Access Compliance Report

Public Rights-of-Way

Intersection ID: 50591	Main Street: GREEN_GRASS_RD	Cross Street: LONGSTRAW_RD	Location: NW
ADA ID: A3AA29CCE73F	Ramp Type: Perp	Initial Pass/Fail: Fail	Overall Compliance: No
		Severity Score: 35

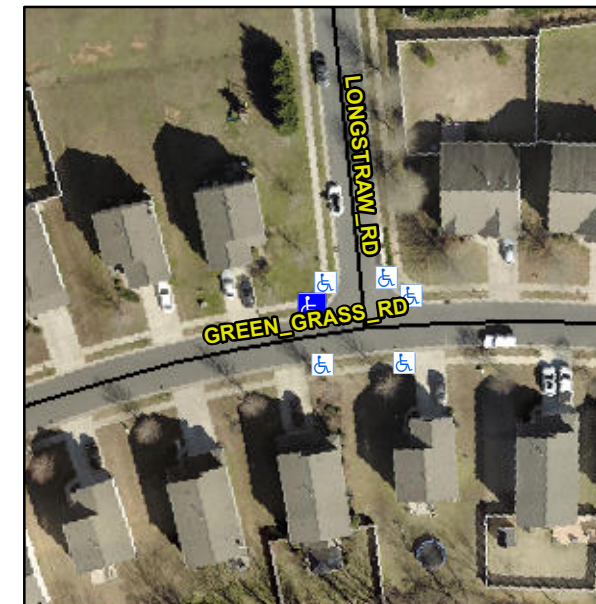
Not Found, R304.5.1, R304.2.2

Compliance	Description	Data	Compliance	Description	Data
N/A	Ramp Length (in)	49.5	No	Ramp Slope (%)	14.0
No	Ramp Width (in)	47.0	Yes	Ramp XSlope (%)	2.7
N/A	Flare Type LT	N/A	N/A	Flare Type RT	N/A
N/A	Flare Slope LT (%)	N/A	N/A	Flare Slope RT (%)	N/A
N/A	Flare Traversable LT?	N/A	N/A	Flare Traversable RT?	N/A
N/A	Landing Length (in)	N/A	N/A	DWS Provided?	N/A
N/A	Landing Width (in)	N/A	N/A	DWS Contrast?	N/A
N/A	Landing Slope (%)	N/A	N/A	DWS Length (in)	N/A
N/A	Landing X Slope (%)	N/A	N/A	DWS Full Width?	N/A
N/A	Landing Curb? (Y/N)	N/A	N/A	DWS Offset (in)	N/A
N/A	Shared Landing?	N/A			
N/A	Gutter Ponding?	N/A	N/A	Gutter Slope (%)	N/A
N/A	Gutter Lip Ht (in)	N/A	N/A	Gutter X Slope (%)	N/A
N/A	Painted X Walk1?	No	N/A	Painted X Walk2?	N/A
	X Walk 1 Direction	To S		X Walk 2 Direction	N/A
N/A	X Walk 1 Width (in)	N/A	N/A	X Walk 2 Width (in)	N/A
	X Walk 1 Slope (%)	2.3		X Walk 2 Slope (%)	N/A
	X Walk 1 X Slope (%)	4.6		X Walk 2 X Slope (%)	N/A

Remove & Replace Entire Ramp.
